**Pill Station and
Ashton Vale Industrial Estate
alternative access
micro-consultations report**

MetroWest Phase 1

June 2016

Pedestrian Access Options

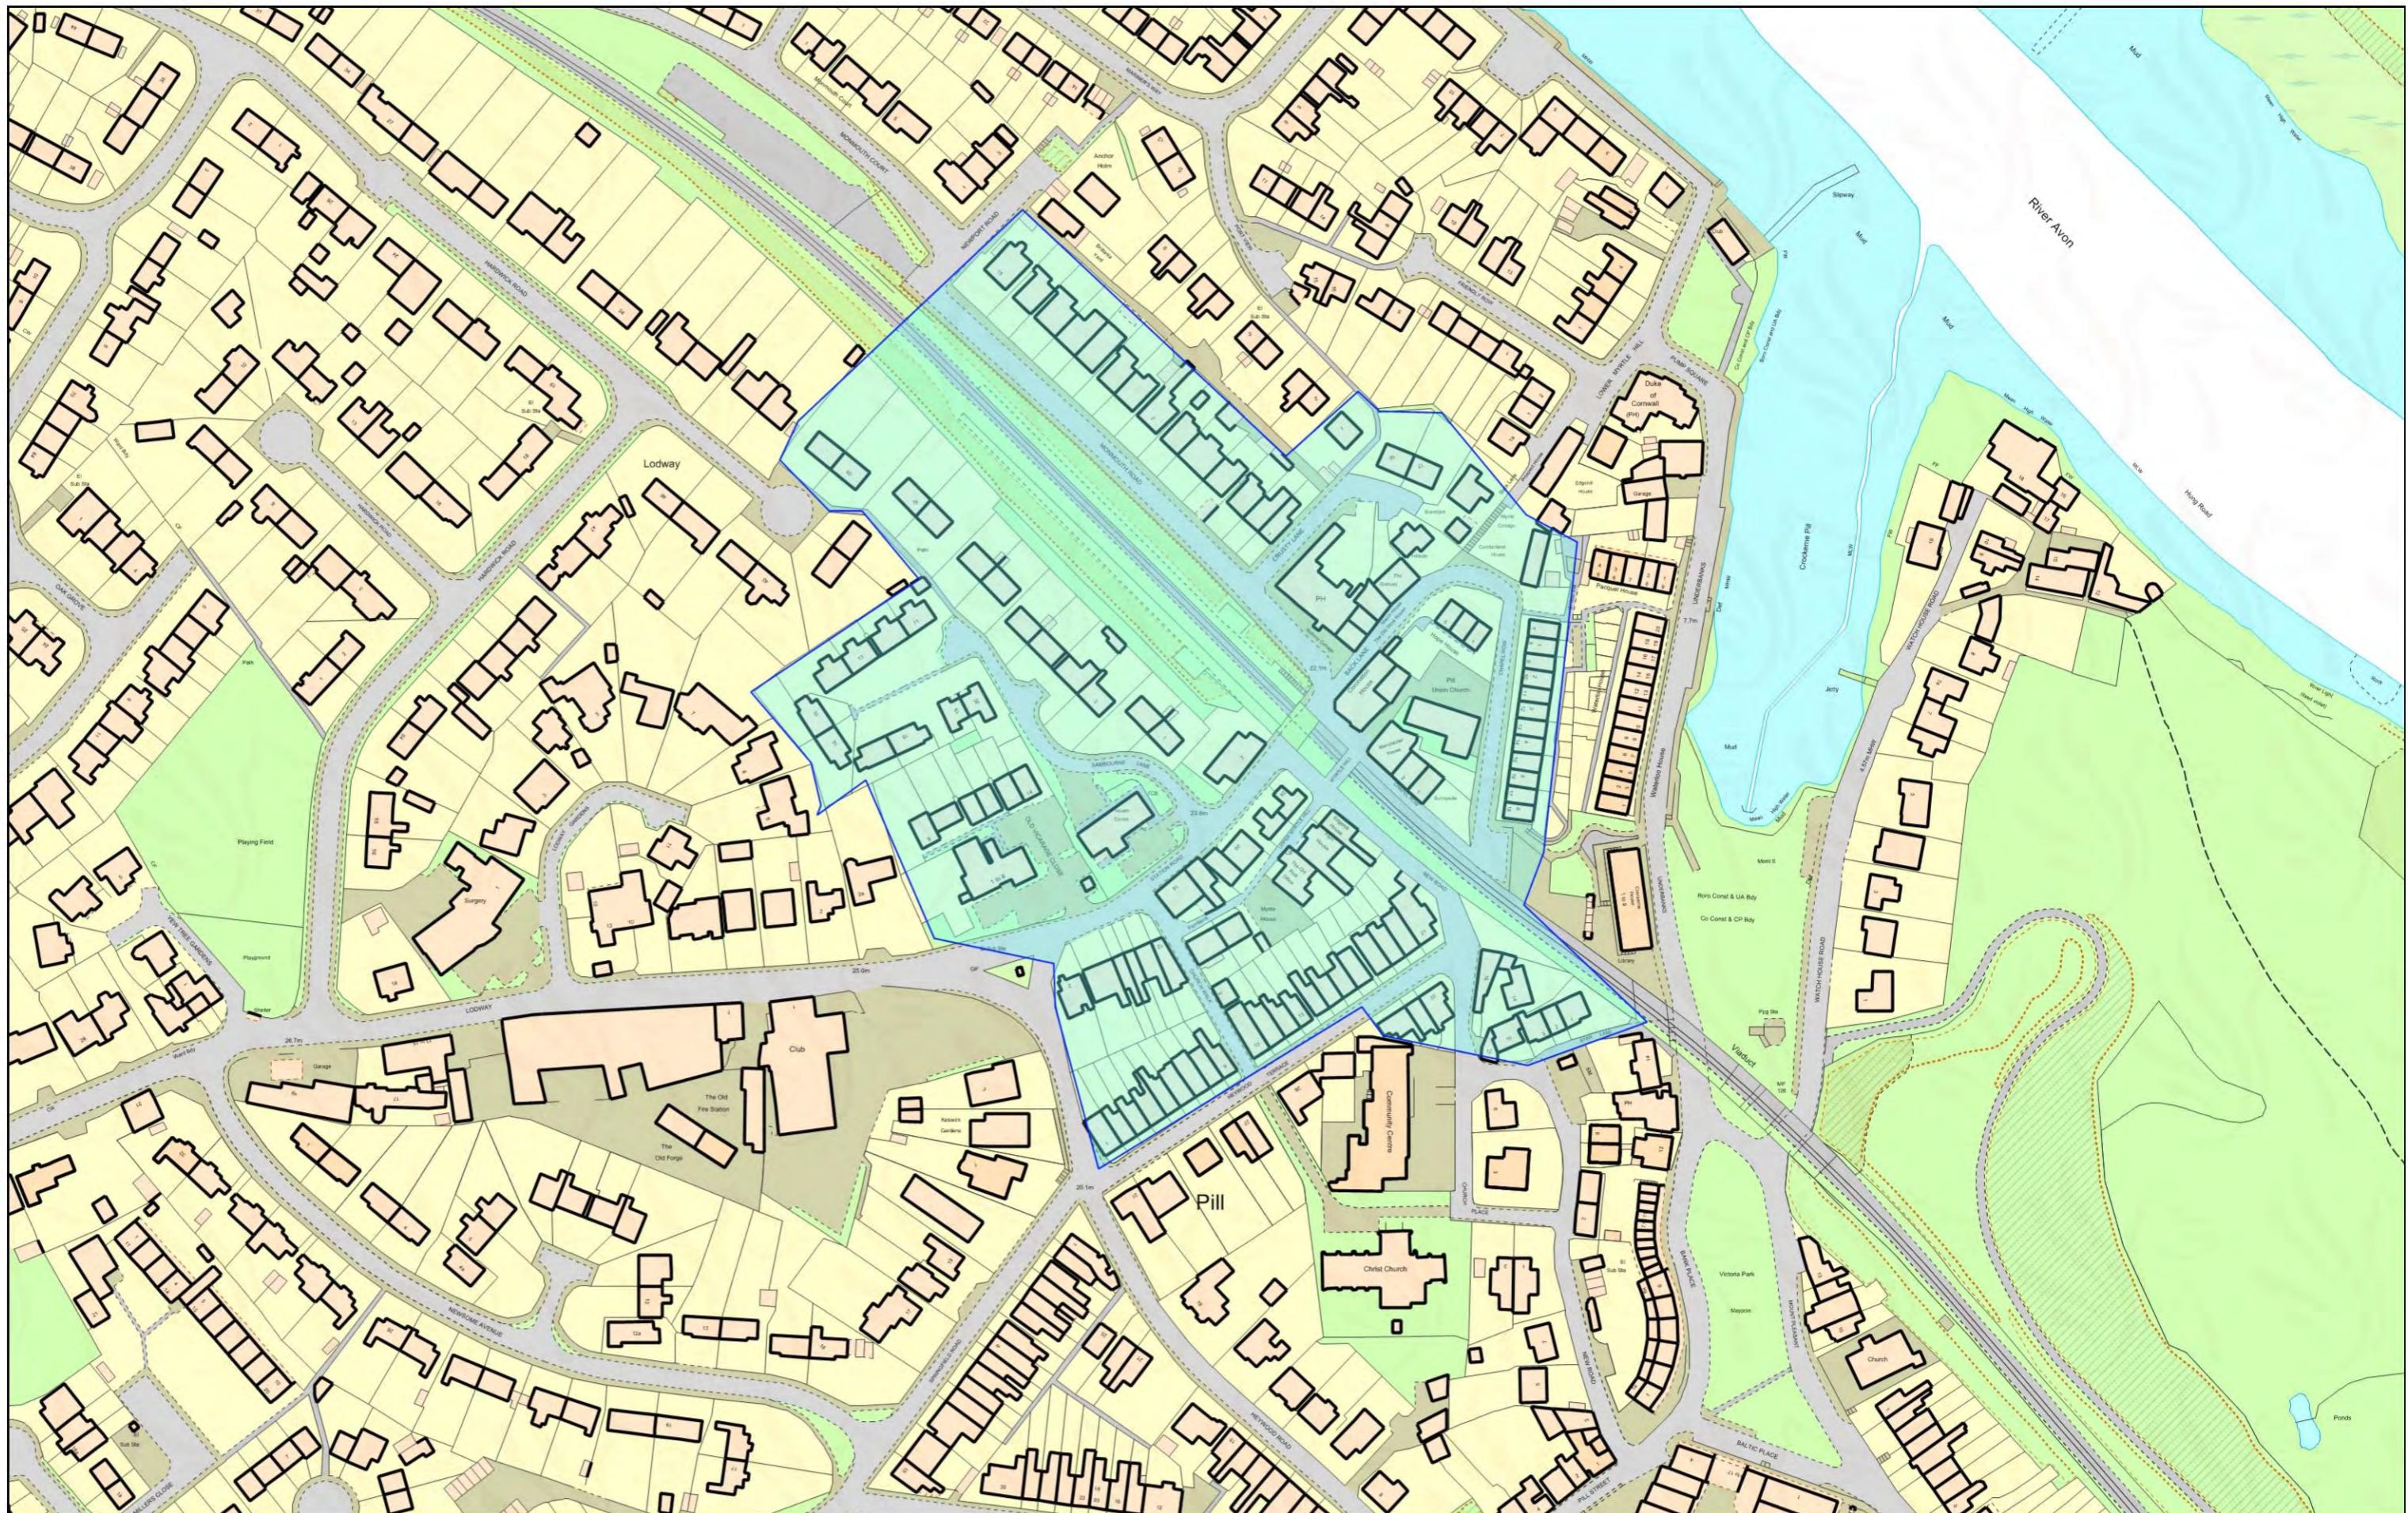
3.23 There were mixed opinions on the alternative pedestrian accesses. There was no clear preference between the two options, with many stating that both would be needed in the event of the level crossing being closed permanently.

3.24 Option A was seen as essential by most of those who commented given its close proximity to the level crossing. It was felt that further design considerations would be needed to ensure it was suitable for pedestrians, cyclists and the less-abled to use safely, including looking at connectivity to and from existing routes from the ramp where it meets the A370. Concerns were also raised about the security of nearby buildings adjacent to the ramp.

3.25 A number of respondents thought that the natural desire line from the industrial estate was to and from the shops and food outlets further south on Winterstoke Road. It was felt that Option A was directing people too far in the opposite direction and could lead to the creation of informal crossing points along the railway if the fence was compromised.

3.26 There were also concerns with regards to the use of the ramp on days when the stadium was in use, as large volumes of people could move onto a width restricted ramp and cause crowding close to the A370 with fast moving traffic.

3.27 Option B was a popular choice, but only if Option A was in place as well. Option B was seen to link the industrial estate, Ashton Vale and MetroBus with Winterstoke Road at a more appropriate point than Option A. Comments

regarding the stadium footfall thought that Option B was the only feasible alternative in the event of the level crossing closure, as it is the desire line for MetroBus passengers alighting at Ashton Vale and walking directly to the stadium without a lengthy detour.

3.28 However if delivered on its own, Option B was considered too far south for people wanting to enter the industrial estate from the north who would need to travel almost 600 metres further in total to reach the same point.

3.29 Many commented that the delivery of Option B should in no way compromise the future use of the site for Ashton Gate station (which is not being delivered as part of MetroWest Phase 1).

Cyclists / pedestrians	Member of public	The two options proposed do not meet the needs of existing cyclists and will not encourage new users to consider the cycle as a viable form of transport for South Bristol.
	Member of public	Scheme will result in increased cycle traffic on routes that at present are mostly used by pedestrians.
	Member of public x 2	Option A has good points but requires dangerous cycling manoeuvres in order to connect with Paxton Drive and Festival Way.
	Member of public x 2	It is not acceptable to provide a new rail connection at the expense of cyclists.
	Member of public x 2	Potential alternative cycle routes are too narrow for shared use, with tight turns and in places adjacent to a 40mph road (plan provided). Cyclist should not be expected to dismount.
	Member of public x 4	Problems can largely be resolved by providing an additional route over unused land in between the allotments and the railway line (plan provided).
